# CFA #2214 TAB Punch List

Prepared by Ben Searles

Apr 13, 2025

IMG\_0820

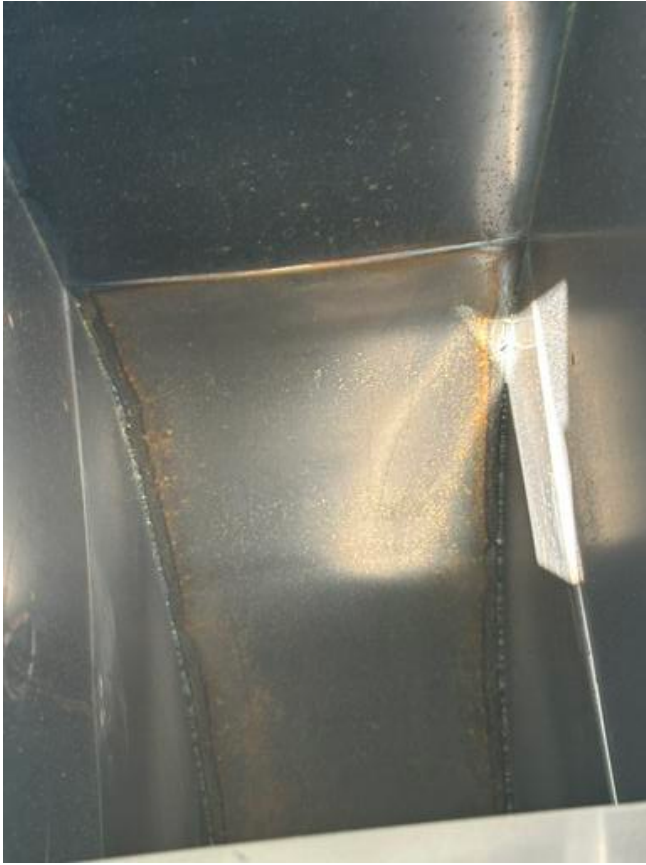
EF1 is low on airflow and can't be sped up. The greaseduct was changed to move the fan closer to hood 1. in doing so, the plans include two consecutive 90 degree turns with no turning vanes. It is believed that this increase in turbulence from the turns is causing the decrease in airflow. Recommend increasing the motor size to 1 HP to account for increased static pressure.

IMG\_0811

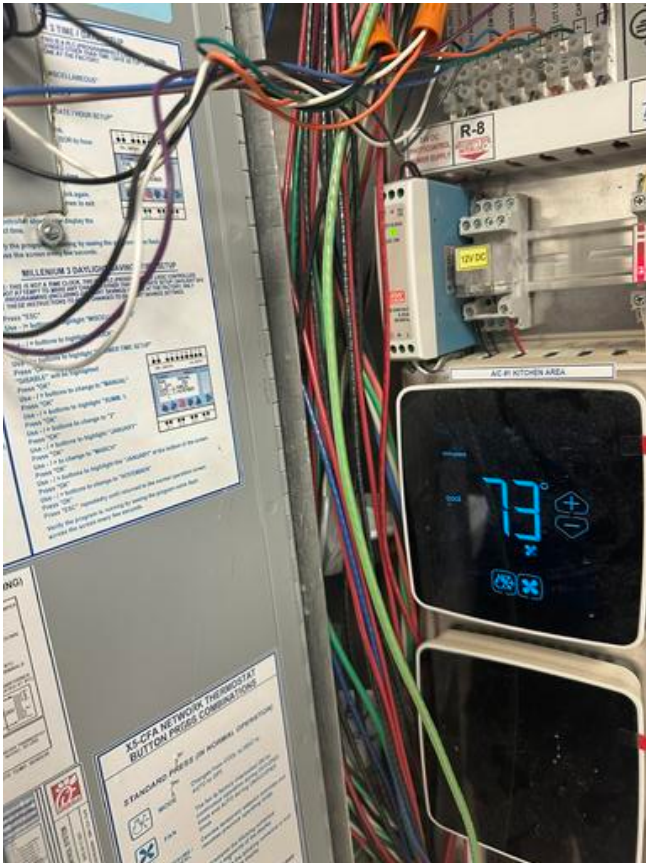
Label all ansul pull stations for which hoods they serve.

IMG\_0801

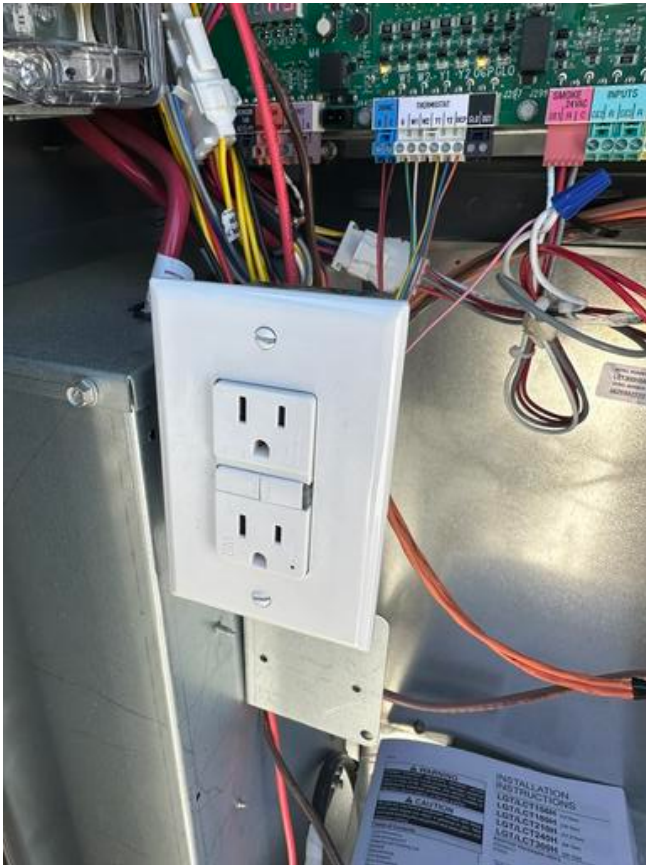
Fire sensor wiring is run through the portal cover without a grommet.
